Subject: N192213490 - Customer Satisfaction Program  
Belt Tensioner Strut

Models: 2019 Chevrolet Silverado 4500/5500/6500

## N192213490 Belt Tensioner Strut

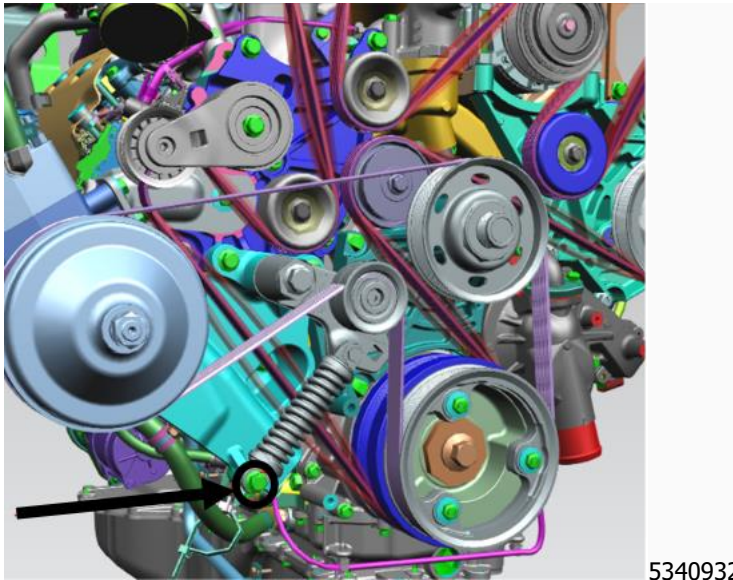
<b>Condition</b>	Certain 2019 model year Chevrolet Silverado 4500/5500/6500 vehicles, may have a condition in which the vehicle was built with an incorrect bolt for the belt tensioner strut.
<b>Correction</b>	Dealers will replace the automatic level control air compressor bracket and the lower belt tensioner bolt. Inspect the air compressor drive belt and drive belt tensioner for any signs of damage or premature wear and replace if necessary.

2. Replace the Automatic Level Control Air Compressor Bracket and the lower Belt Tensioner bolt, as shown above. Refer to *Air Compressor Bracket Removal* and *Air Compressor Bracket Installation* in SI.
  - Inspect the Air Compressor Drive Belt and Drive Belt Tensioner for any signs of damage or premature wear. If any damage or premature wear is noted, replace those components as well.
3. Reinstall the Automatic Level Control Air Compressor. Refer to *Automatic Level Control Air Compressor Replacement* in SI.
